SKILLING, HELLE, CHRISTIANSEN, ROBERTSON — Structural & Civil Engineers

PROJECT THE WORLD TRADE CENTER | TITLE FIELD REPAIR EL 310 SPANDREL TOWER 'A' | DATE 3-12-71

SECTION A-A

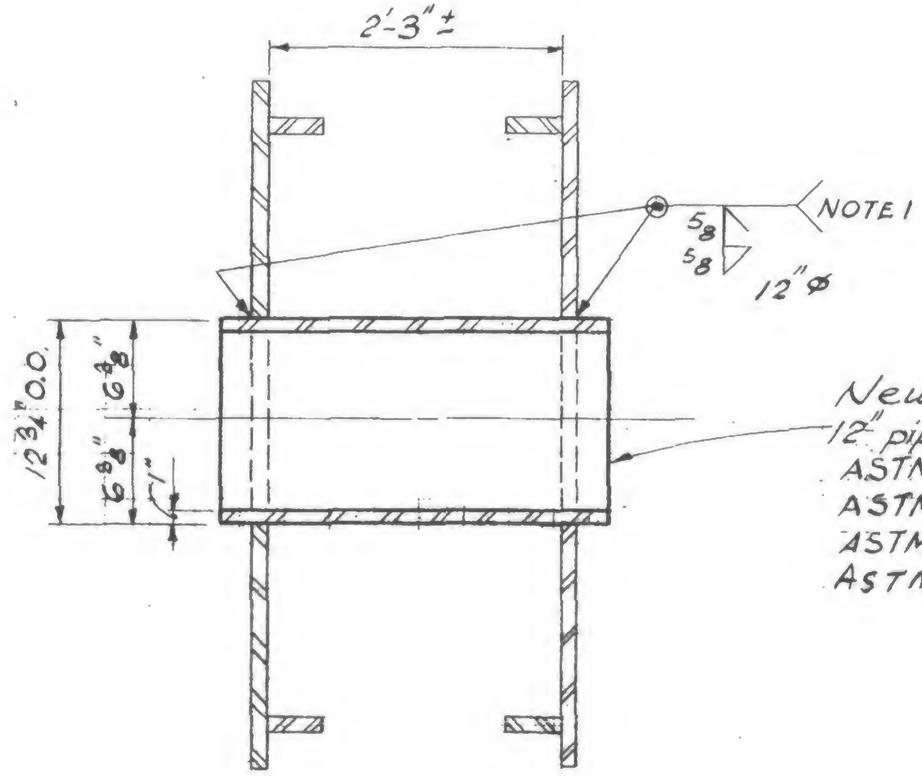
Cut bevel in existing spandrel ℄'s with air-arc gouge. Increase fillet weld size by 1/16 inch for each 1/16 inch of clearance between spandrel ℄ and pipe in excess of the first 1/16 inch of clearance.

New
12" pipe xx strong x 2'-9" long
ASTM A53 Grade B
ASTM A500 Grade B } Contractors option
ASTM A501
ASTM A36
